Subject: Response to City of Los Angeles Geology and Soils Report Review Letter
Proposed Apartment Complex
1185 West Sunset Boulevard, Los Angeles, California

GEOLOGY AND SOILS REPORT REVIEW LETTER

LOG # 127750-01
SOILS/GEOLOGY FILE - 2

CROSS SECTION B-B'

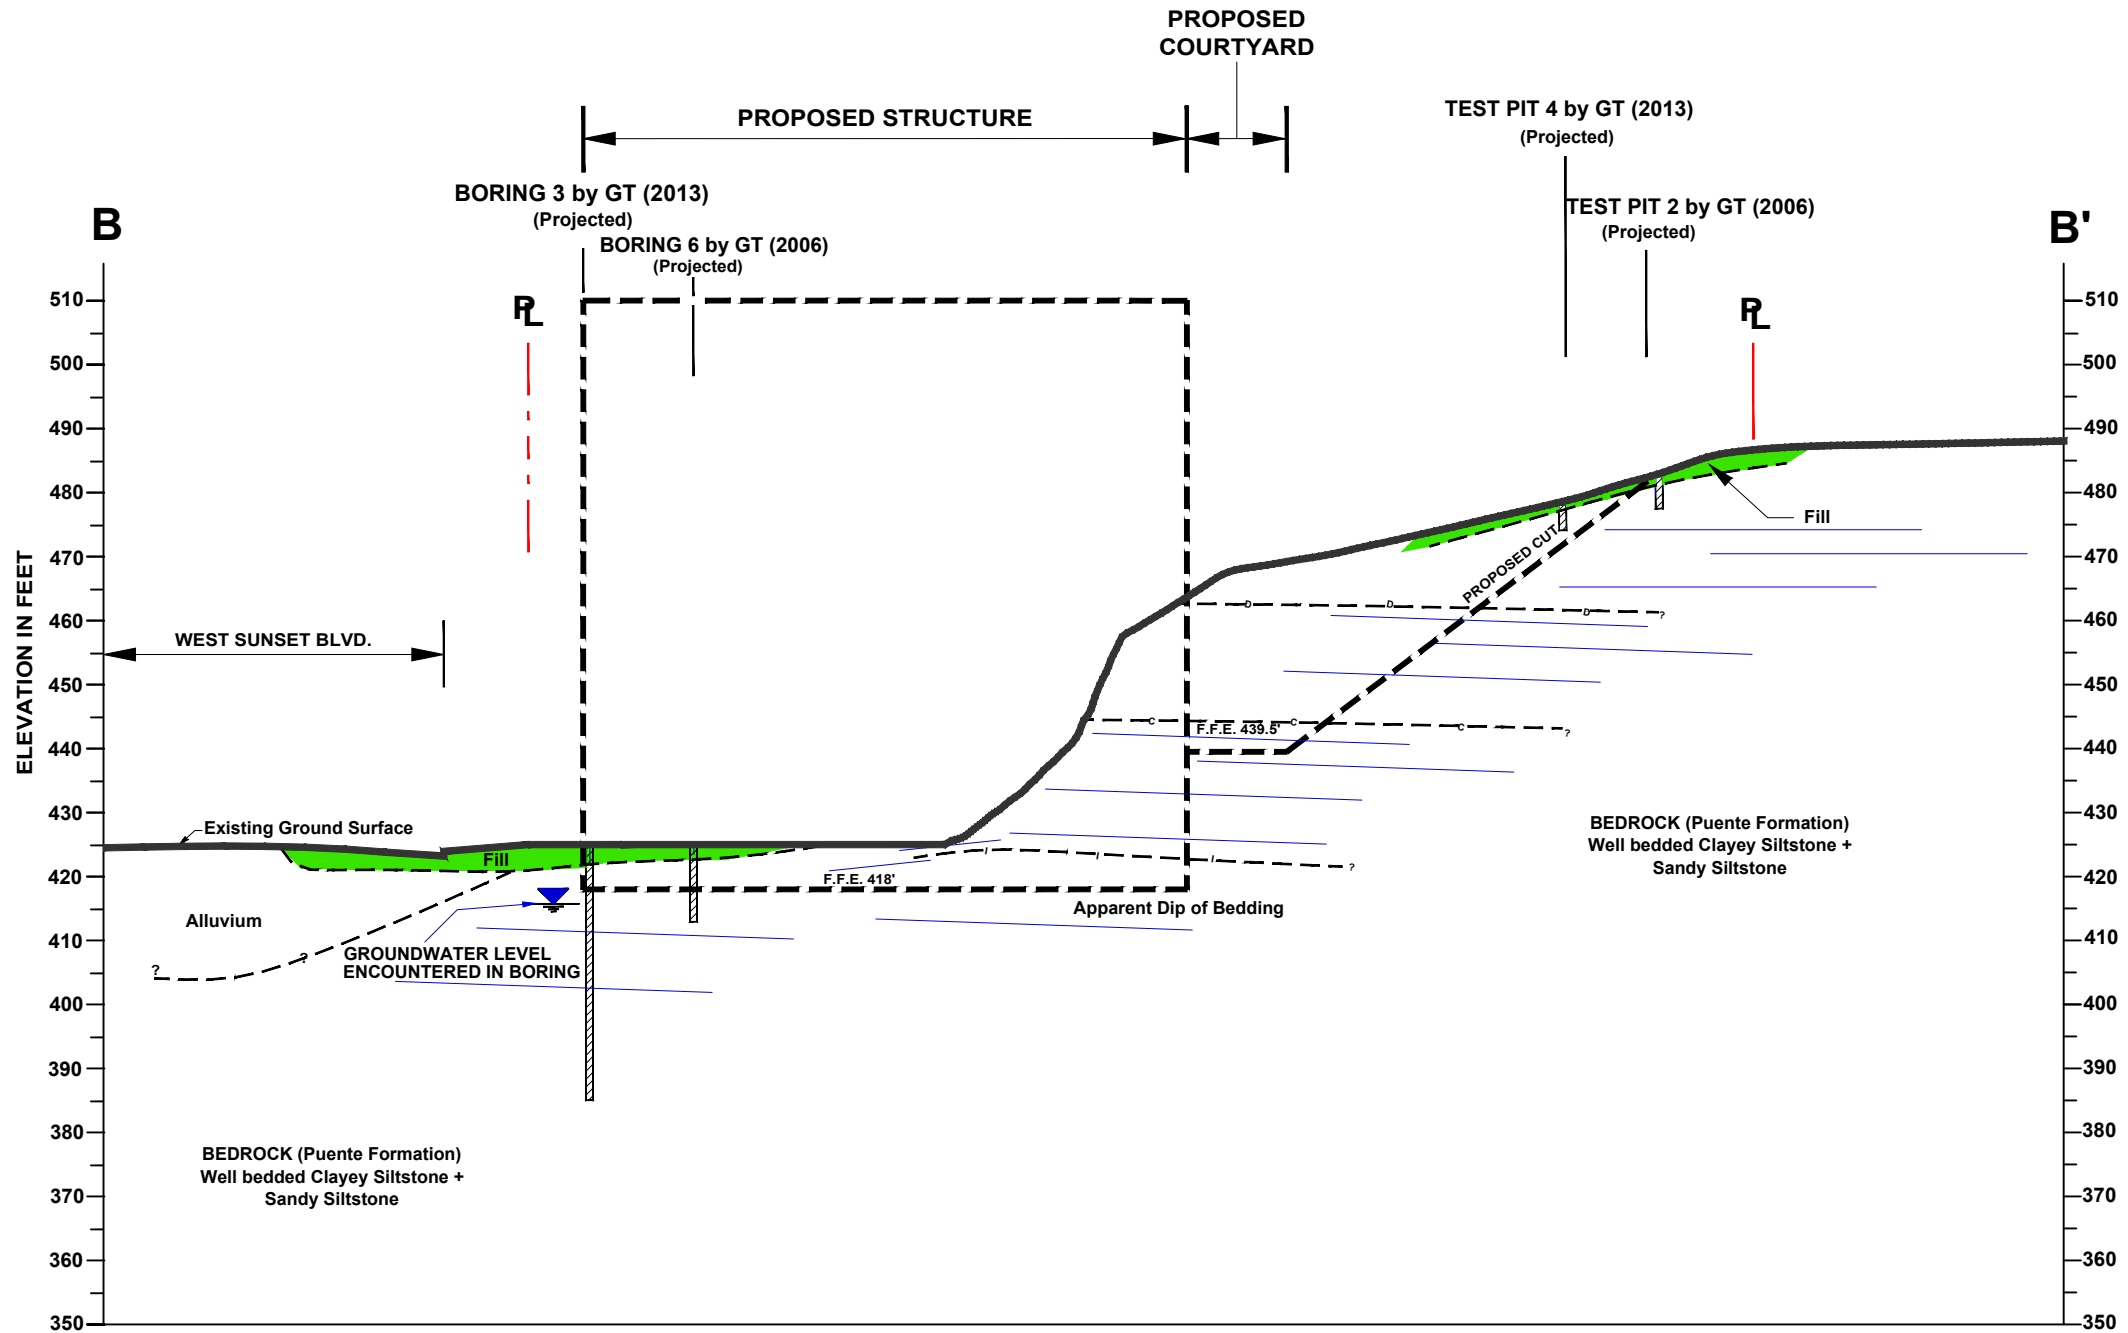
Comment 1: *As previously requested, Cross Sections B-B', E-E', and F-F', do not appear to provide the Code required setback of the proposed building from the toe of the ascending slope (1808.7.1). Provide revised Geologic Cross Sections that clearly depict the Code required setback. It appears that the proposed building sets at the toe of slope and the terrace cut is inside the building envelope.*

1. As previously requested, Cross Sections B-B', E-E', and F-F', do not appear to provide the Code required setback of the proposed building from the toe of the ascending slope (1808.7.1). Provide revised Geologic Cross Sections that clearly depict the Code required setback. It appears that the proposed building sets at the toe of slope and the terrace cut is inside the building envelope.

Response: The Plot Plan, Geologic Map and Cross Sections A-A' through H-H' have been revised to clearly depict the proposed building location. A 15-foot-wide setback separates the proposed building and the toe of the easterly-ascending slope. The setback is being utilized as a courtyard.
